BID Addendum-01

Project No.
JCDT23-0185

Title
Bid Clarification 01

Project Name
St Clair County Heath Dept Relocation

Drawing Title
SOUTH WING - ROOF MECHANICAL PLAN

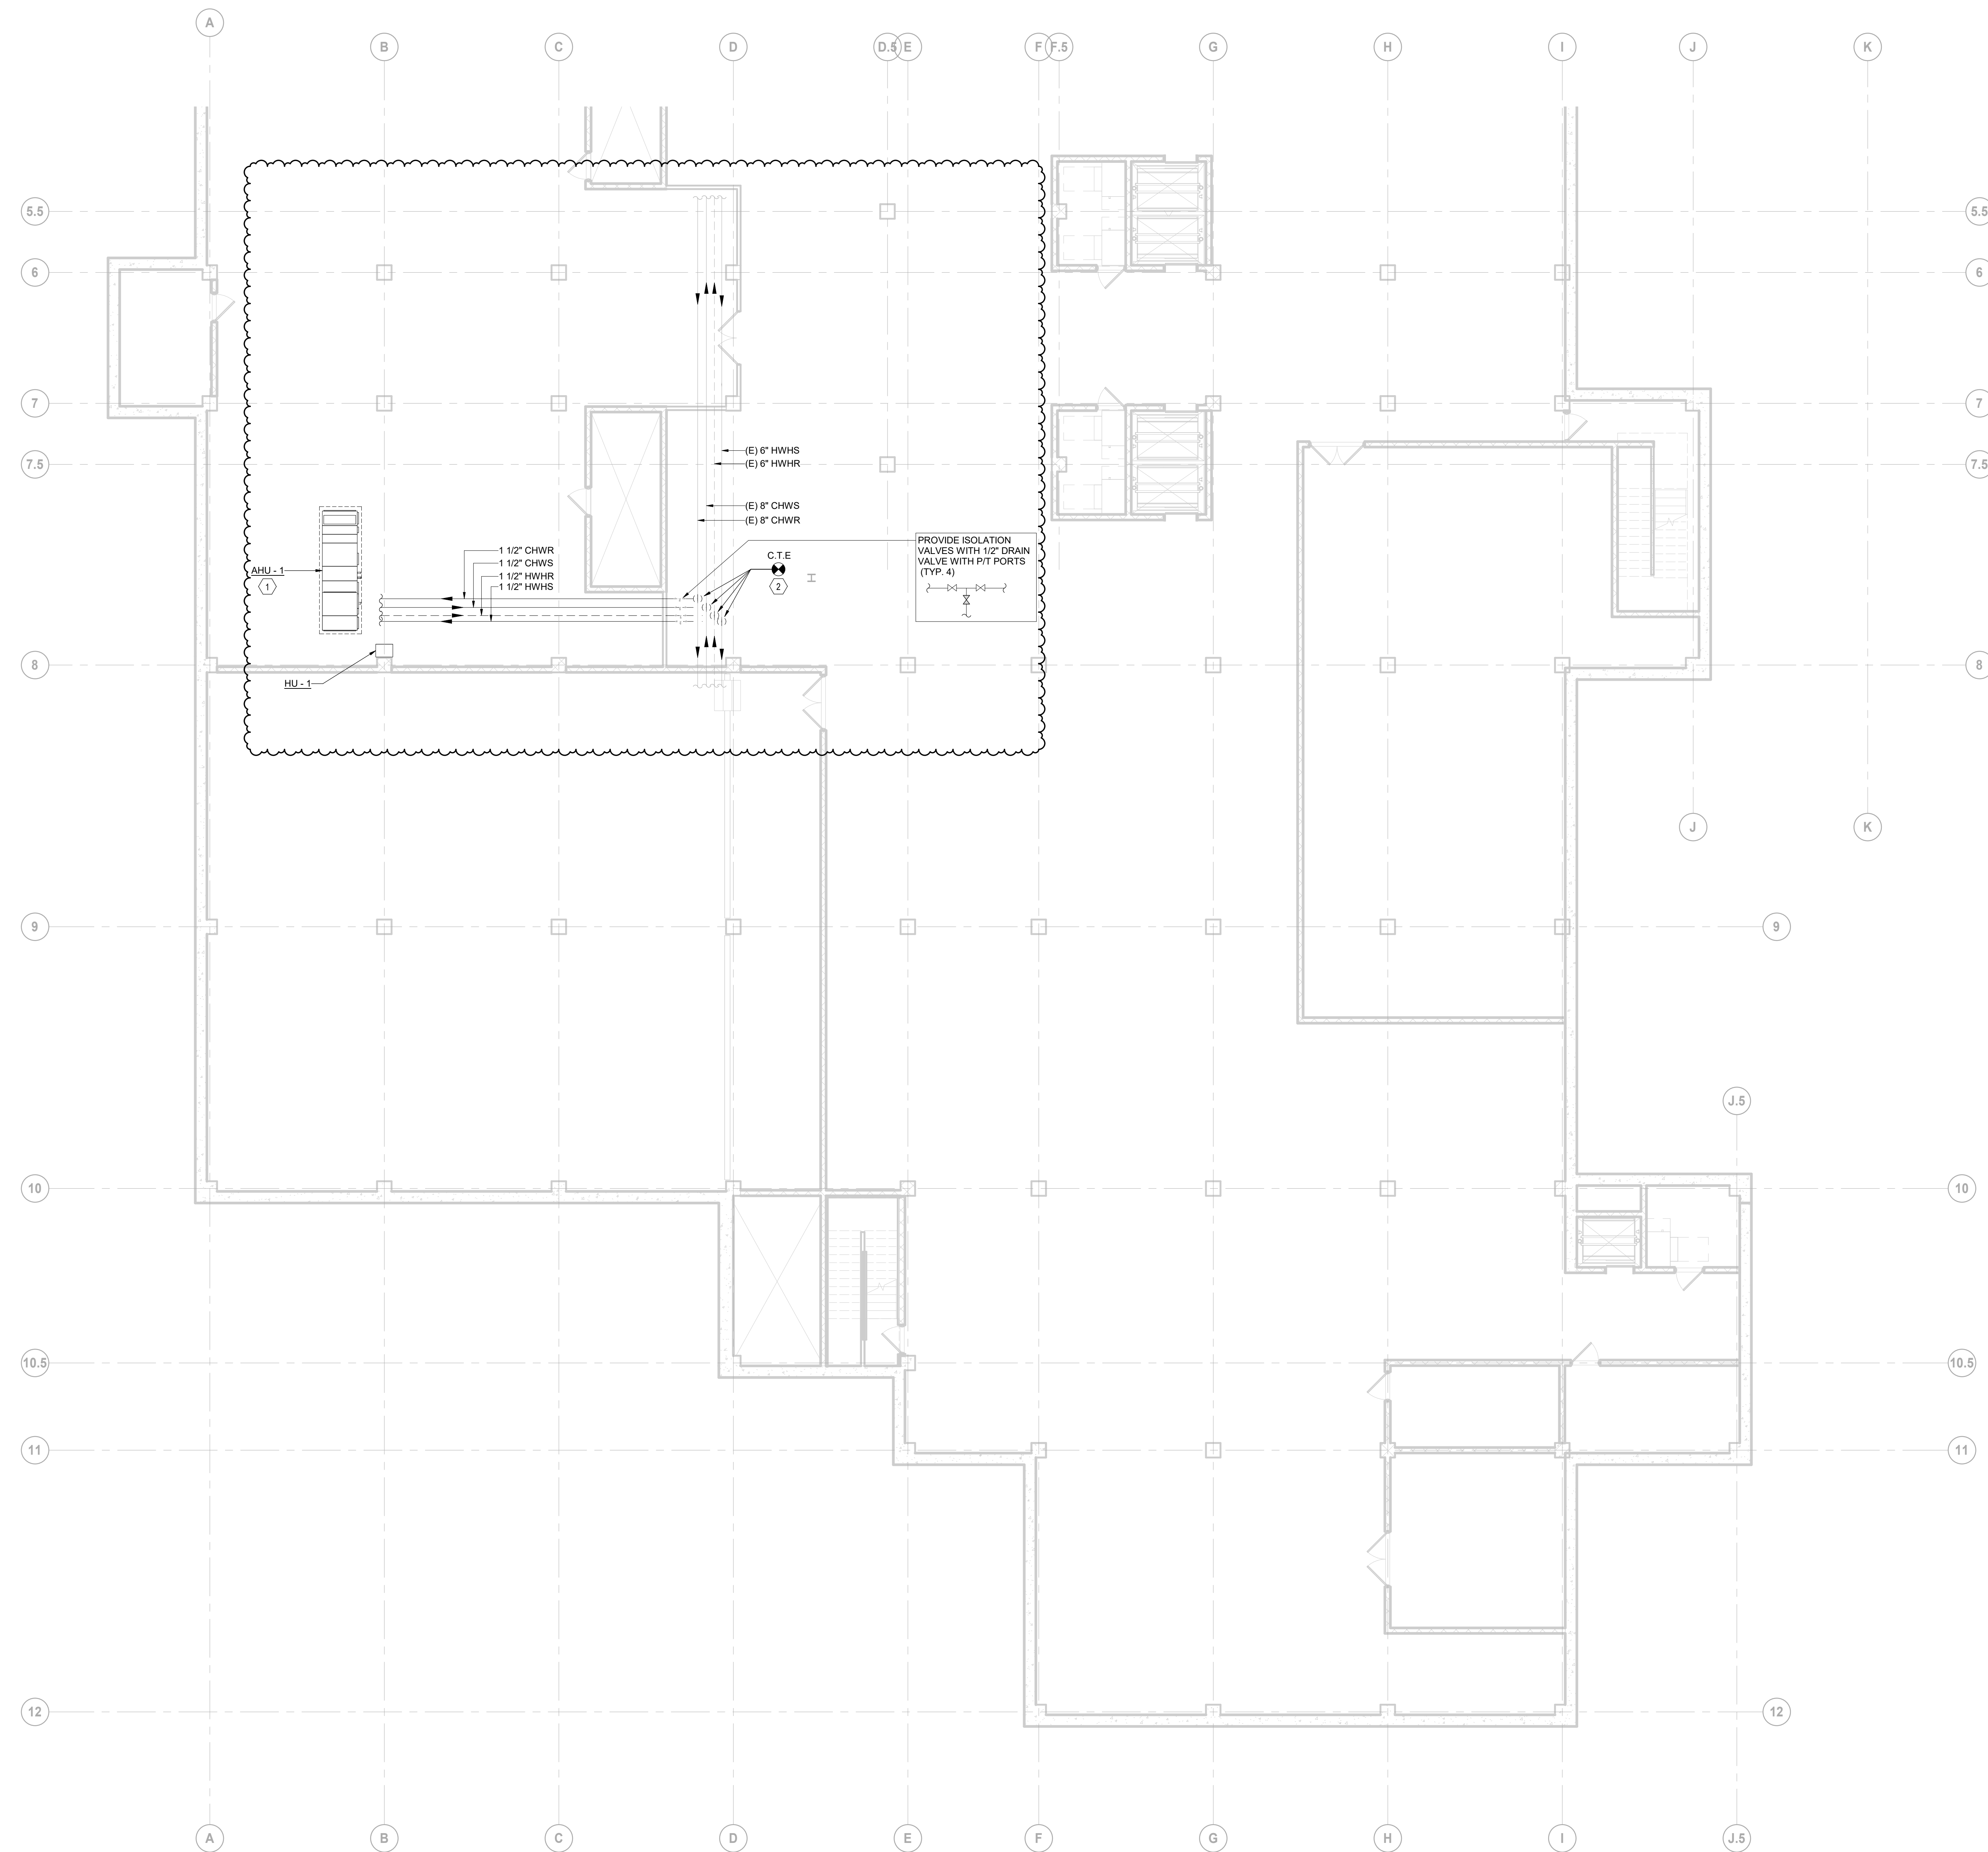
- c. CAVV-A included for supply ductwork to laboratory 214.
 - d. Added thermostats.
13. Dwg No M50-03
 - a. Added CU-1,2 to rooftop plan.
 - b. Added EF-1,2,3 to rooftop plan

1 SOUTH WING - BASEMENT HYDRONIC PLAN
 SCALE: 1/8" = 1'-0"

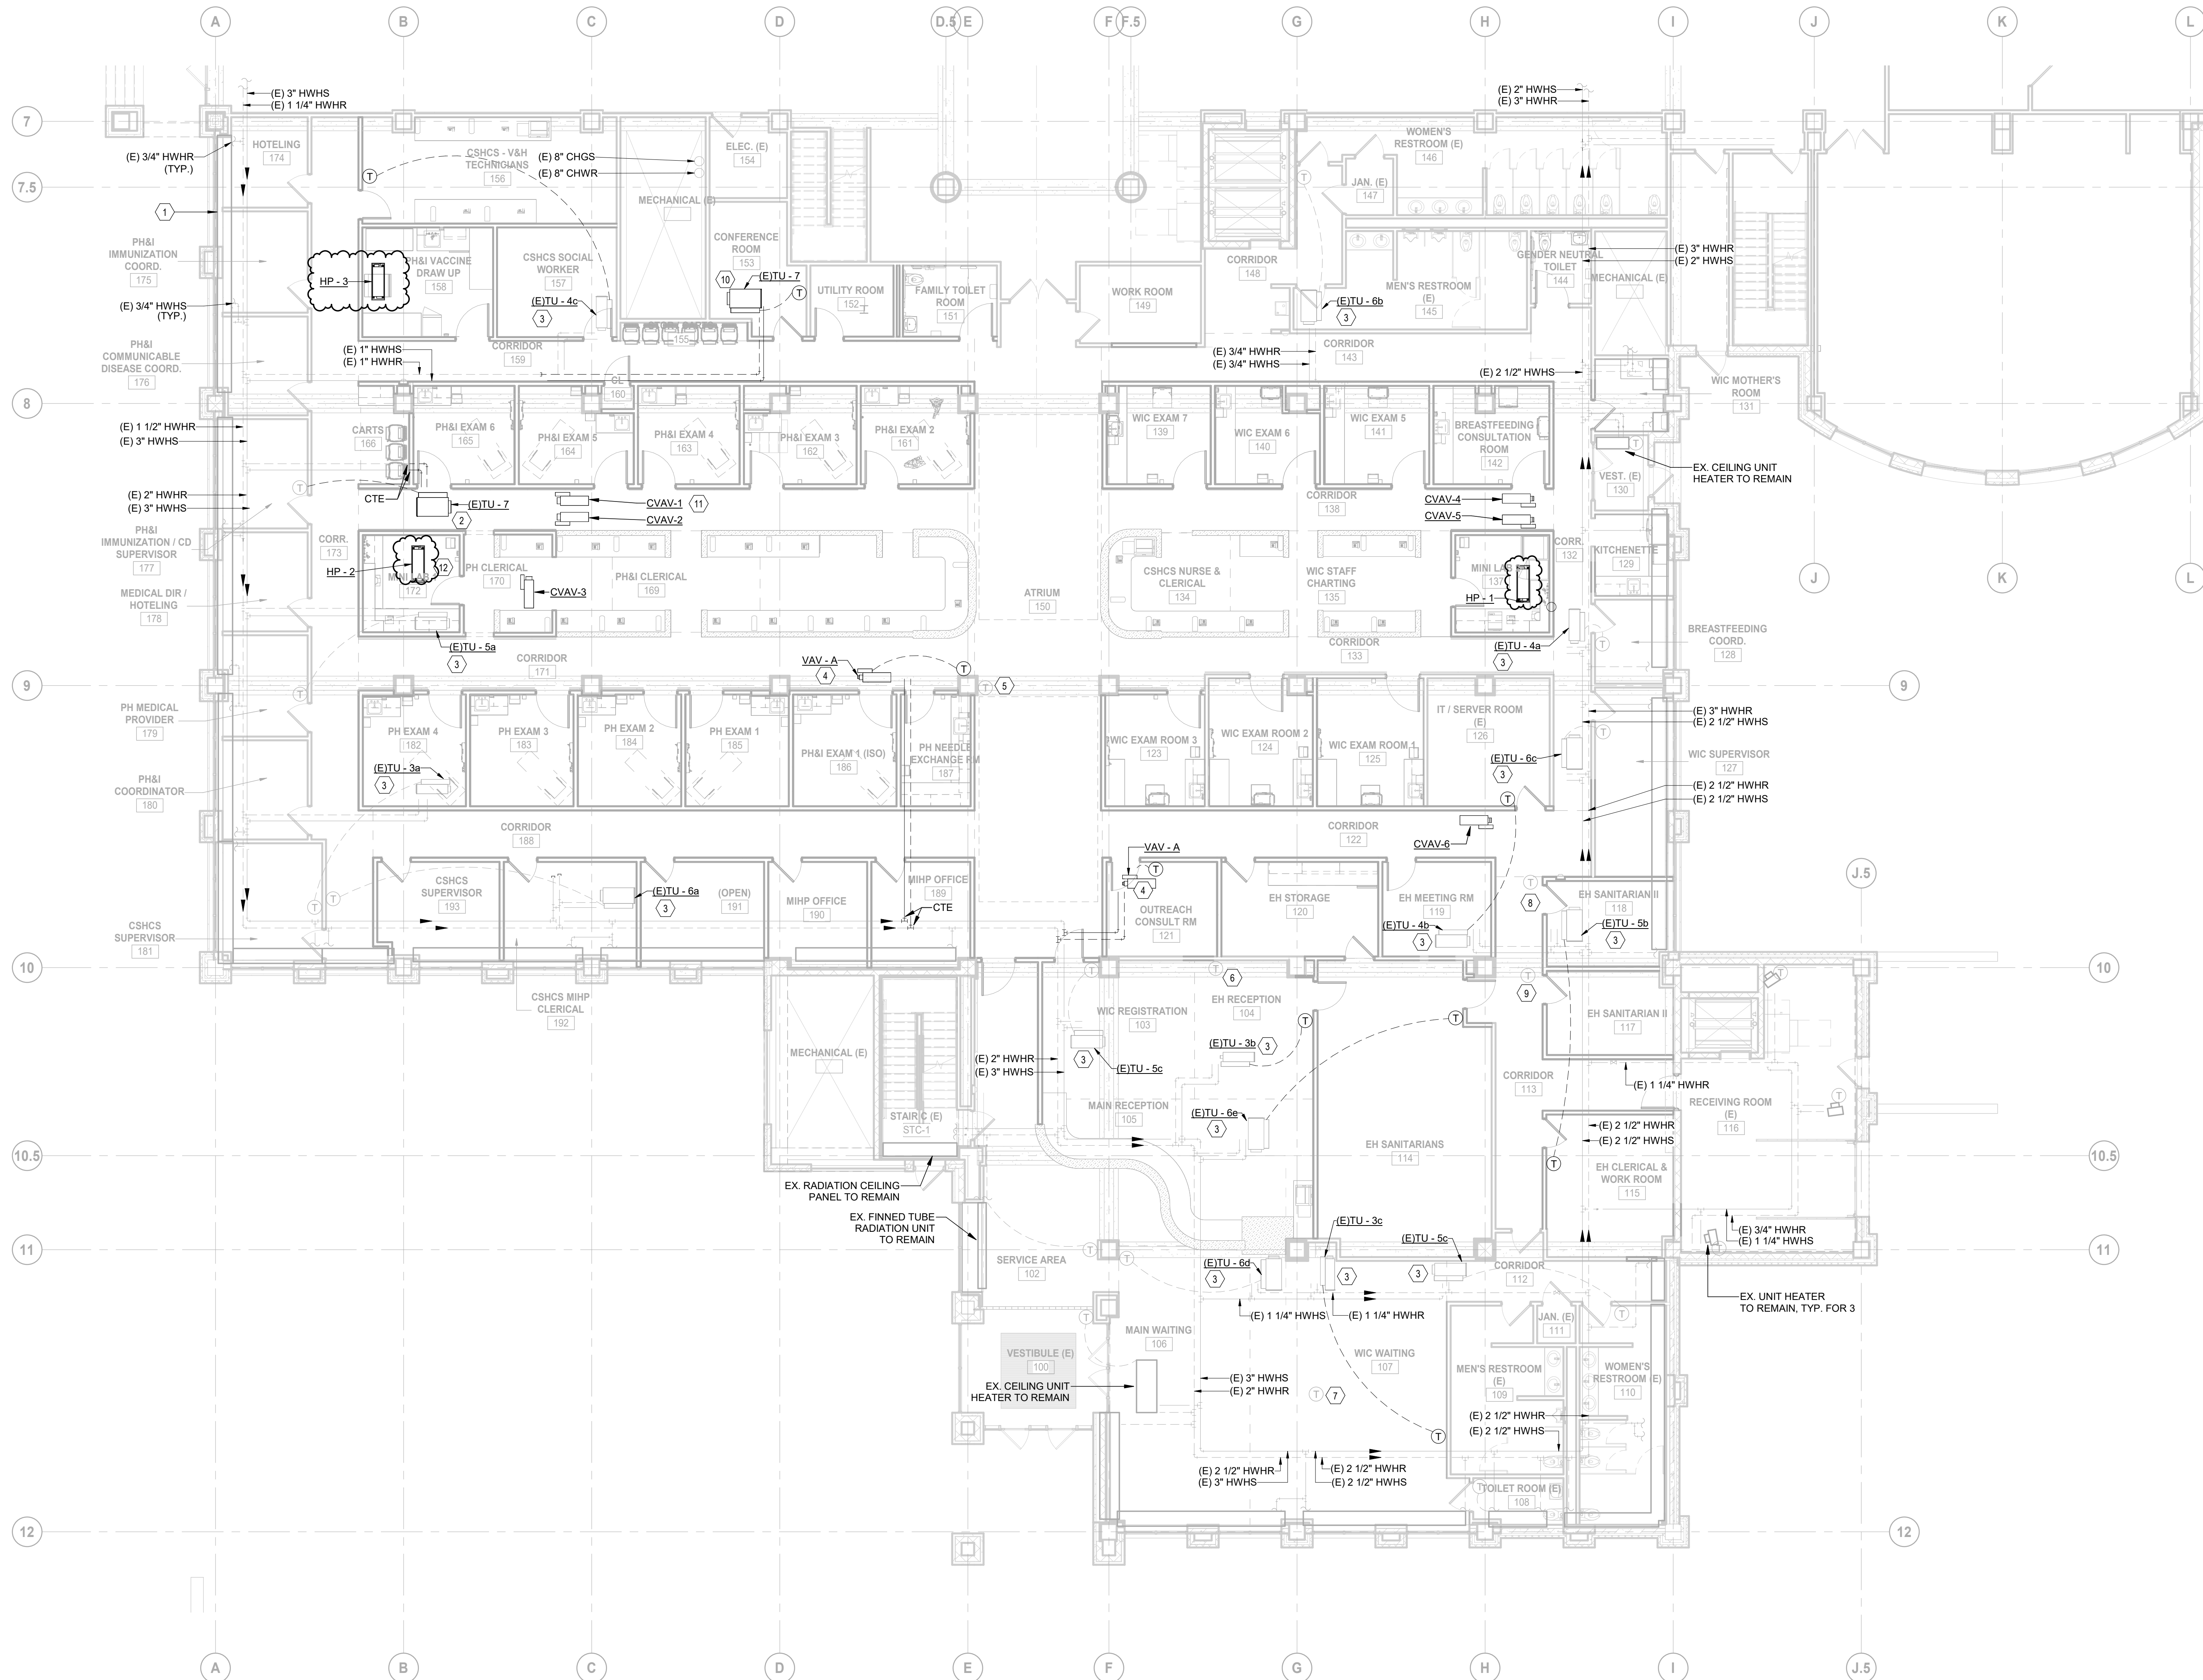
14. Dwg No M53-00
 - a. Adjusted hydronic piping and humidifier for new AHU-1 location.
 - b. Added isolation and drain valves for the new piping connections.

Project
St. Clair County Health Department Relocation
 220 Fort Street
 Port Huron, MI 48060
 Drawing Title
SOUTH WING - LEVEL 1 HYDRONIC PLAN

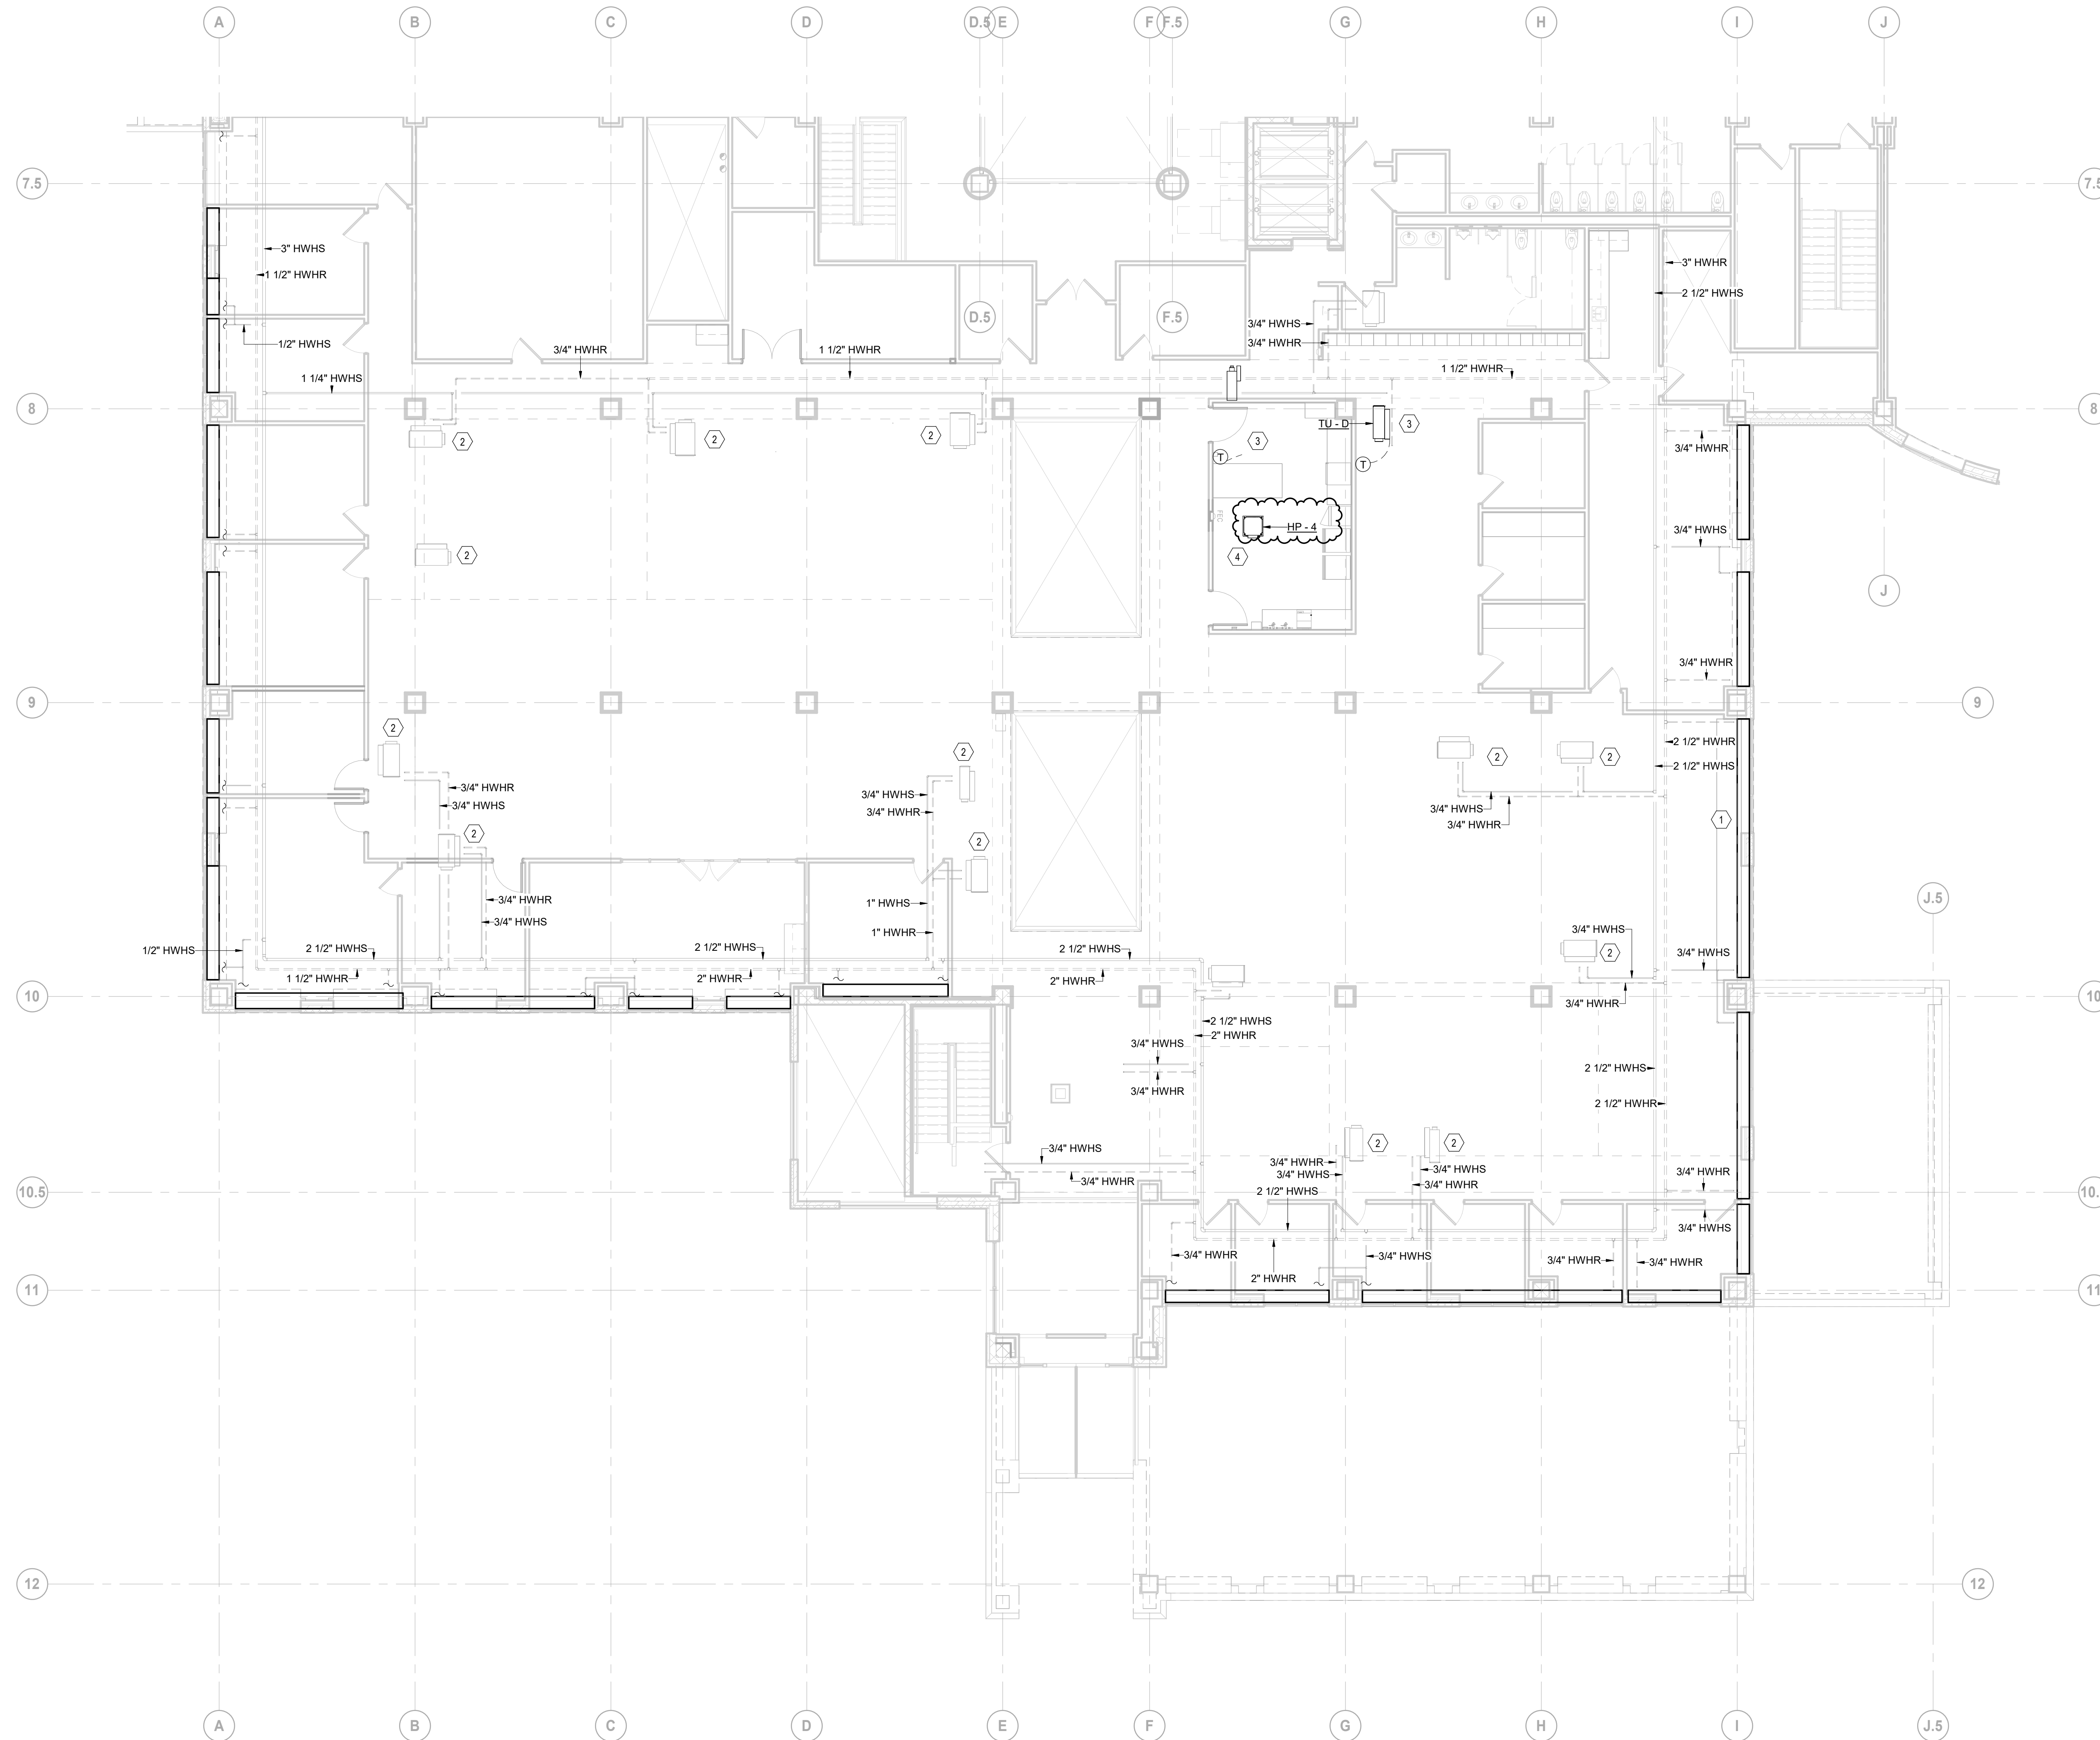
15. Dwg No M53-01
 - a. Updated condensing unit condensate piping on plan to be routed to nearest drain with indirect connection.
 - b. T-stats shown on plans connected to VAVs.
